REMARKS

Amendments to the Drawings:

FIG. 1

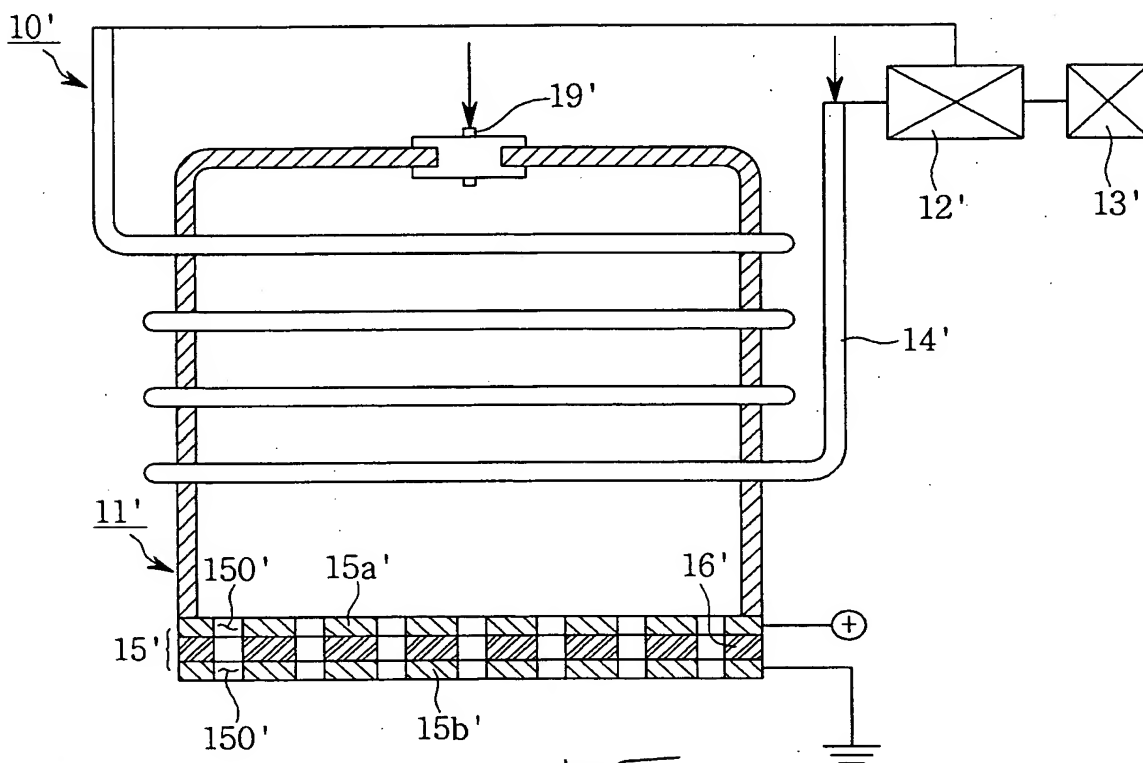
The Office Action indicated that the Figures 1, 2A and 2B should be designated by a legend such as --Prior Art--. Applicants have amended Figures 1, 2A and 2B to label them as "PRIOR ART".

The specific changes which have been made to Figures 1, 2A and 2B is to include the legend "PRIOR ART".

PRIOR ART
